Errata Sheet

Product Family: DL205
Manual Number D2-ANLG-M
Revision and Date 7th Ed., Rev. B; April 2010

Date: July 8, 2013

Page 6-7. Connecting the Field Wiring; RTD - Resistance Temperature Detector; Lead Detection for RTD Sensors

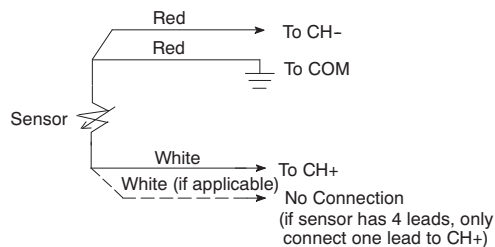
Replace the wiring diagram with this one. The wire lead colors changed. (The two black leads changed to red and the two red leads changed to white.)

Page 6-8. Wiring Diagram

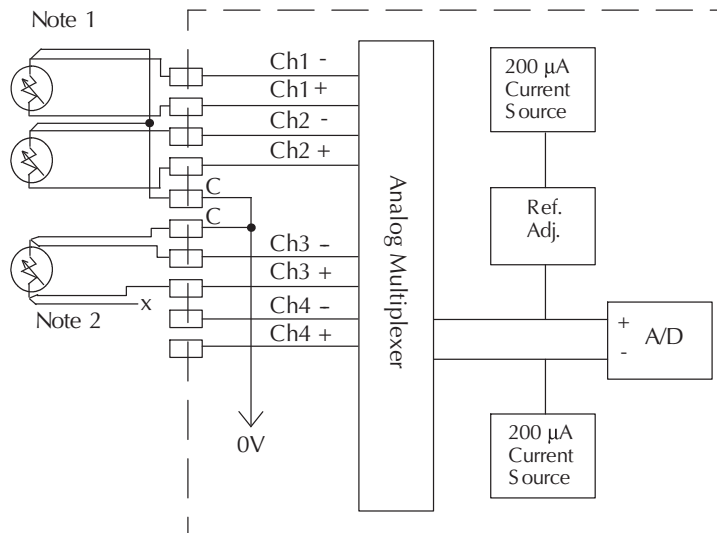
Replace the wiring diagram with this one:
